STATE OF NORTH CAROLINA  
DEPARTMENT OF TRANSPORTATION

**Addendum No. 2**

RE: Contract # C205165

SITES 936-940, 942-944, 314, 316-321, 941: US-176 FROM 0.1 M N OF THOMPSON RD TO 0.8 M EAST OF BEAR CREEK LN. W03293

PROJECT REFERENCE NO. <b>W03293</b>	SHEET NO. <b>12</b>
RW SHEET NO.	
ROADWAY DESIGN ENGINEER 	HYDRAULICS ENGINEER 
<b>DOCUMENT NOT CONSIDERED FINAL UNLESS ALL SIGNATURES COMPLETED</b>	
 <b>TGS ENGINEERS</b> 201 W. MARION ST., STE 200 SHELBY, NC 28150 PH: (704) 476-0003 CORP. LICENSE NO.: C-0275

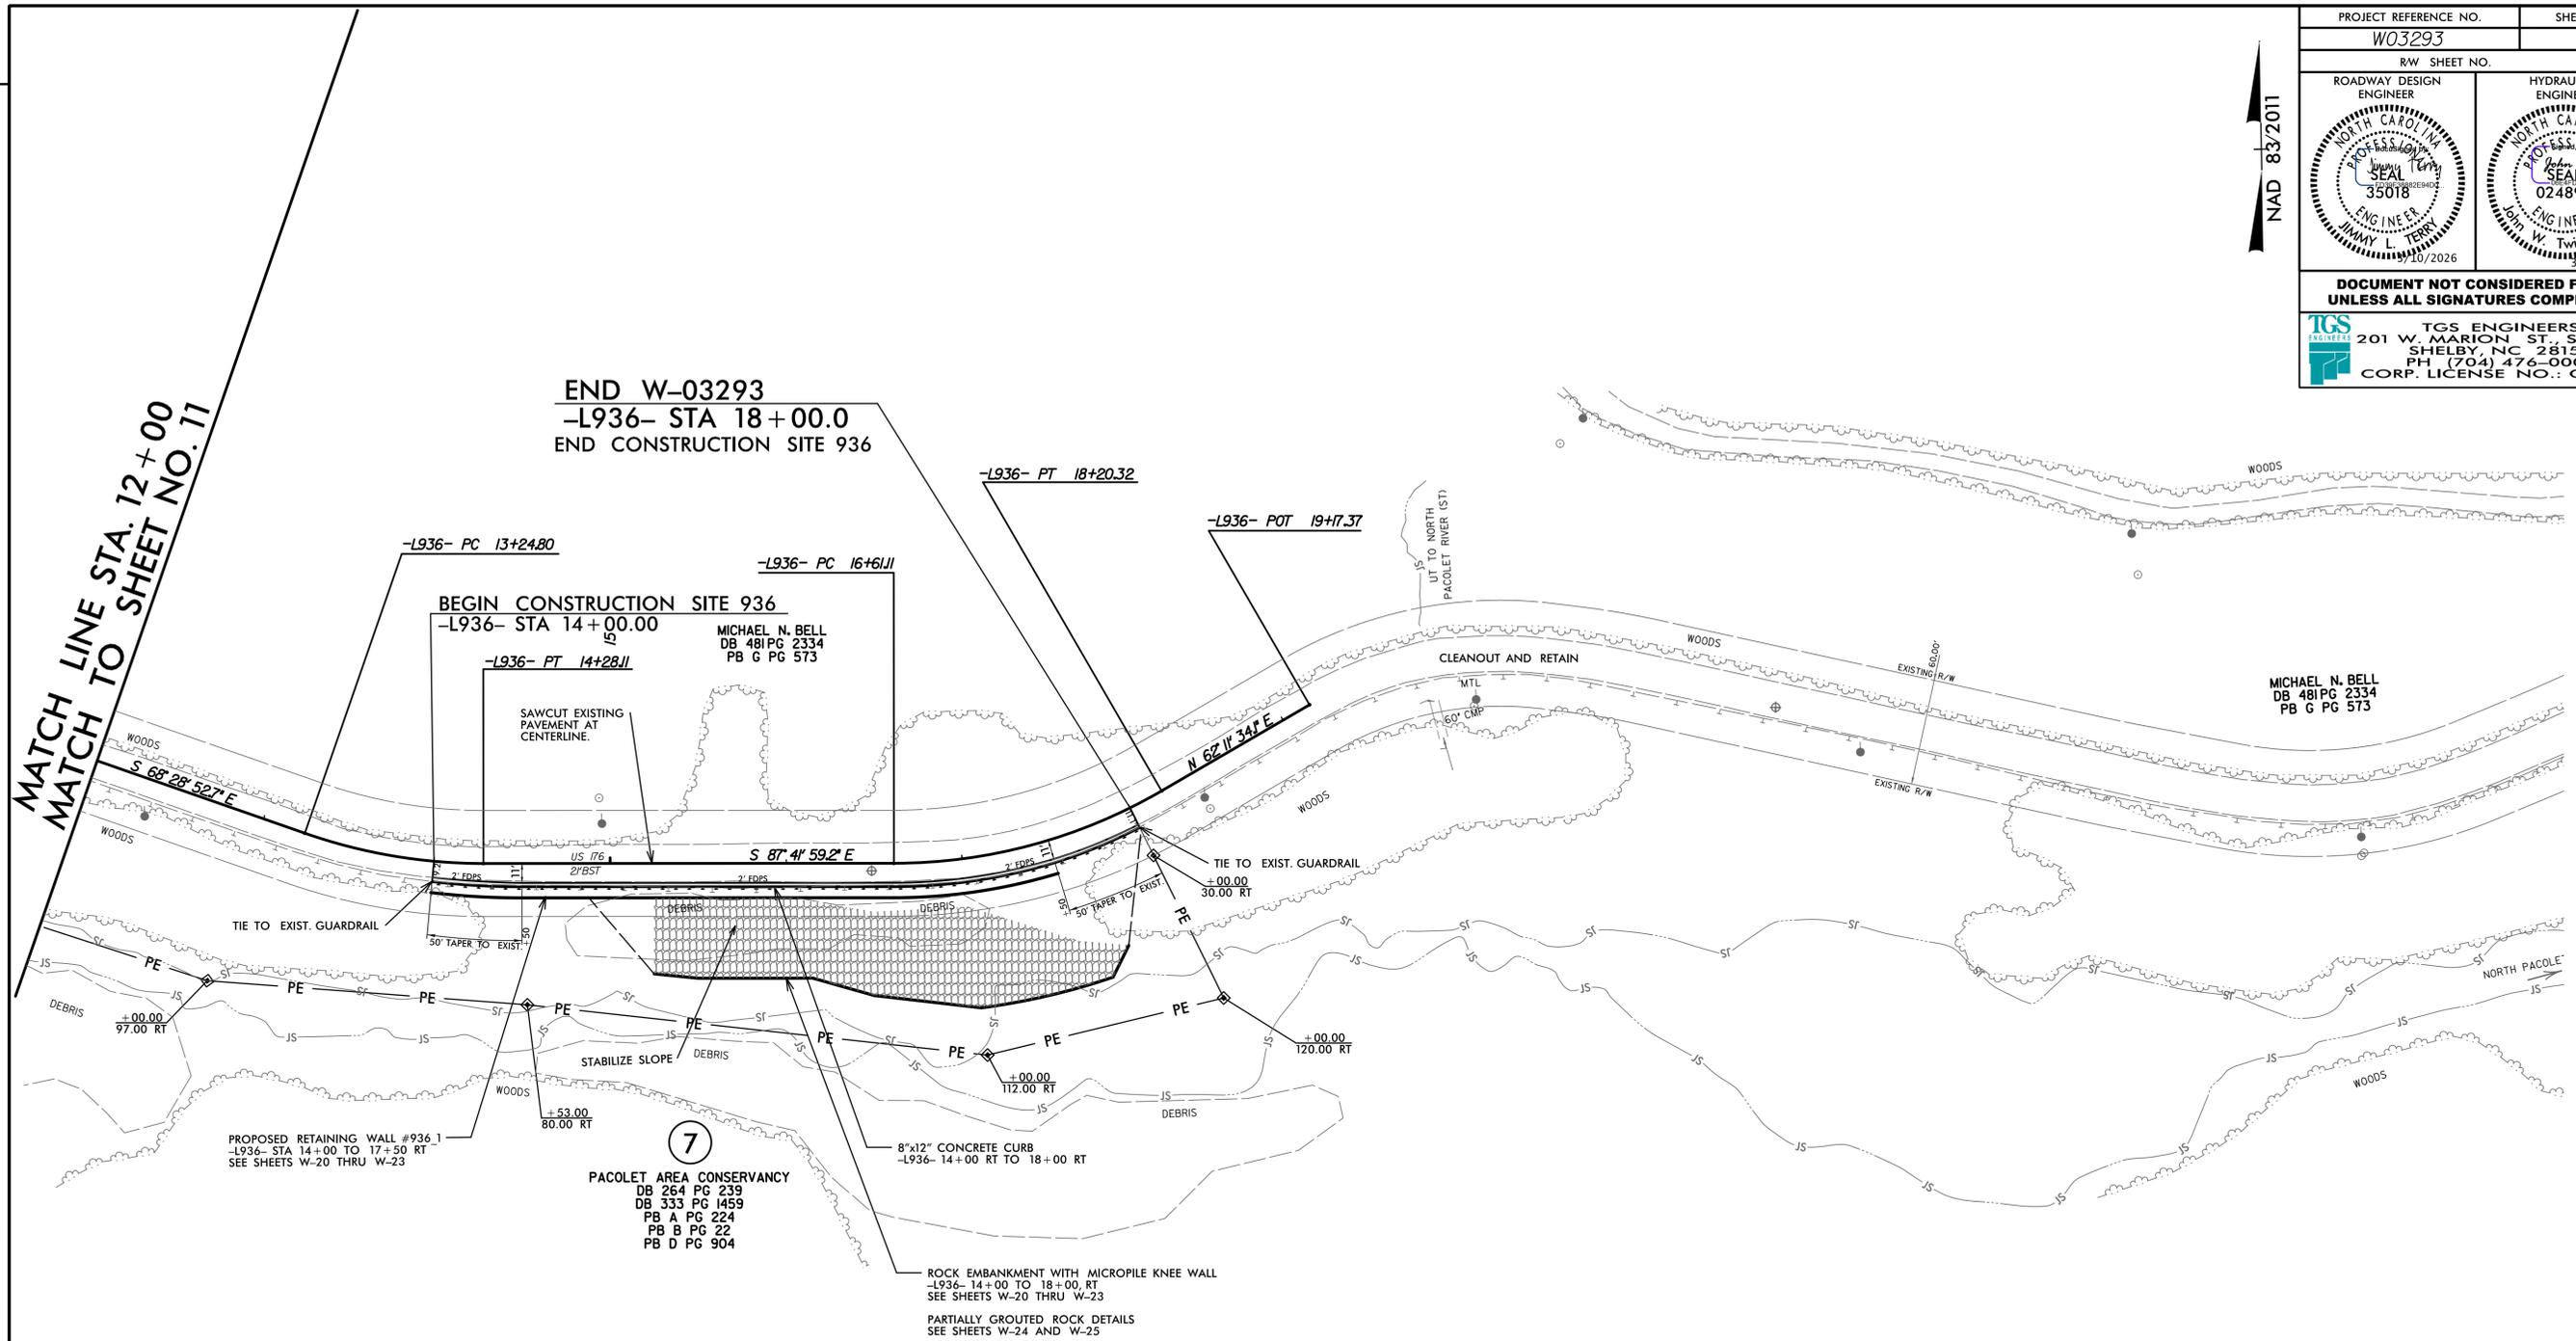
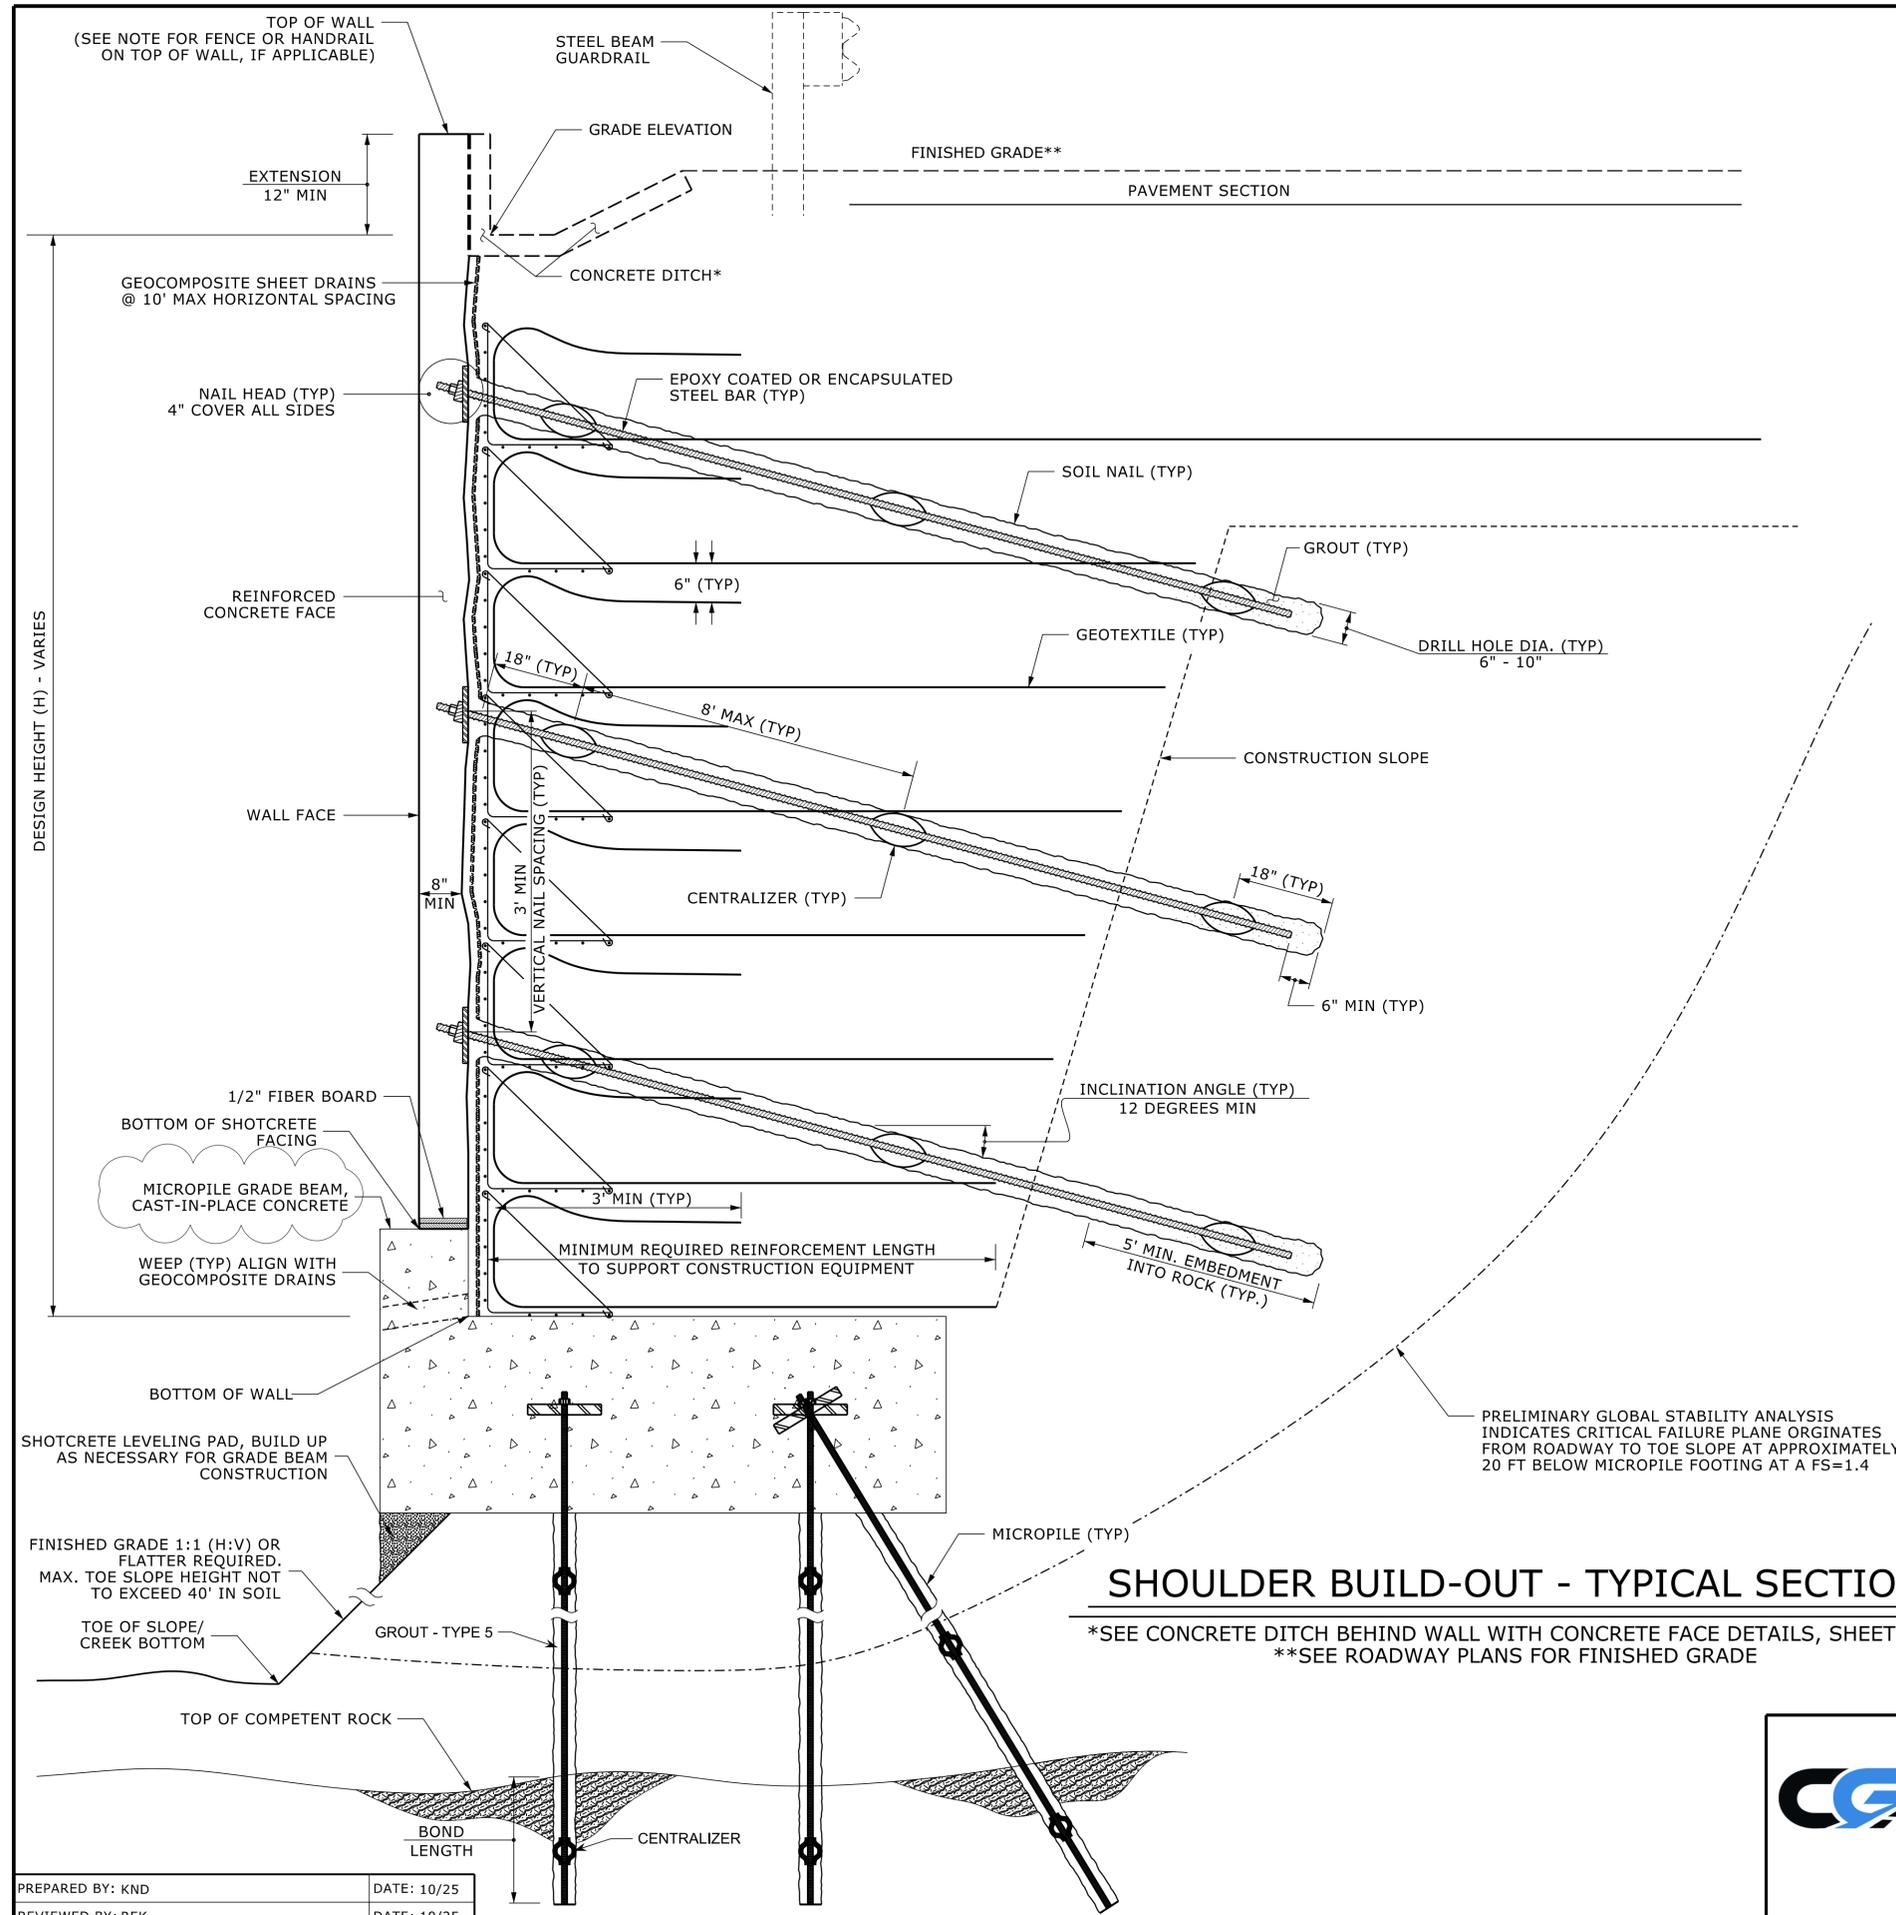
Sheet No.	Revision
3D-1 (Part 1)	Updated Totals and Combined Project Totals – Quantities shown below.
3D-2 (Part 1)	Revised label for “Combined Project W03293 Totals”.
6 (Part 1)	Revised note for DS-600.
3D-2 (Part 2)	Revised quantities – shown below.
12 (Part 2)	Revised – removed “grade to drain” note.

REVISIONS						SHEET NO. W-5
NO.	BY	DATE	NO.	BY	DATE	
1	KND	03/26	3			
2			4

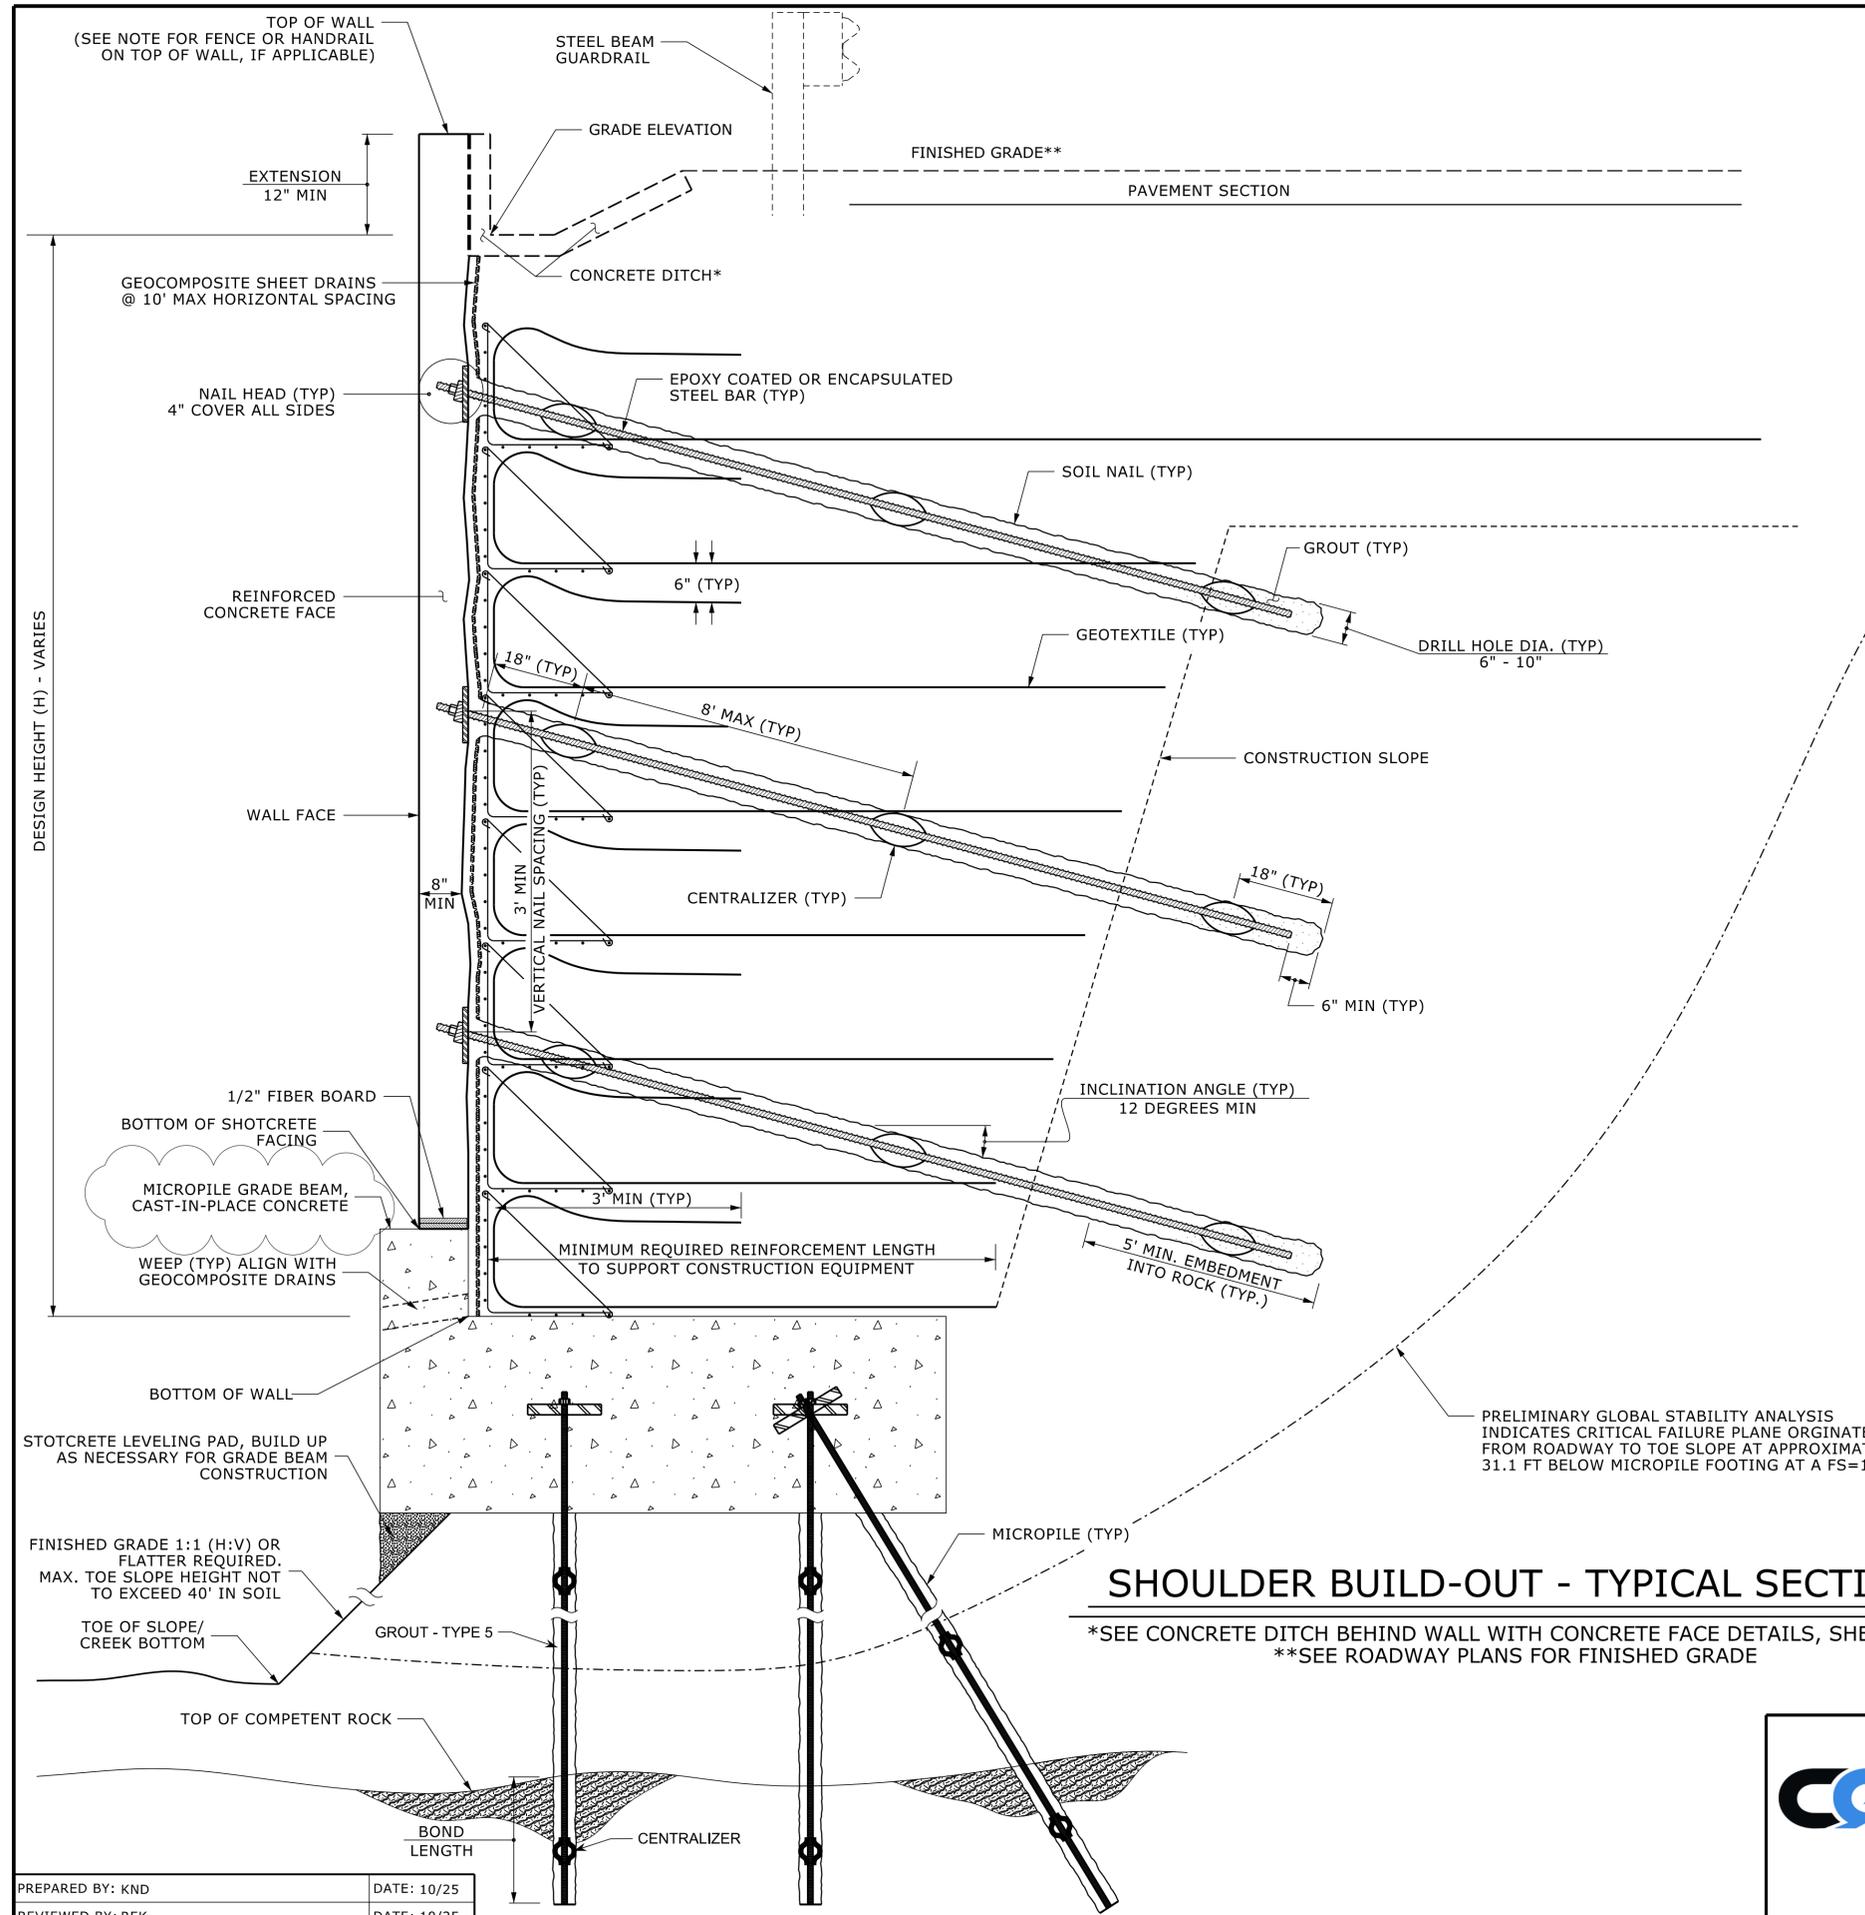
Sheet No.	Revision
W-5 (Part 1), W-7 (Part 1), W-7 (Part 2), W-9 (Part 2), W-13 (Part 2), W-17 (Part 2)	Revised call-out to read “MICROPILE GRADE BEAM, CAST-IN-PLACE CONCRETE”
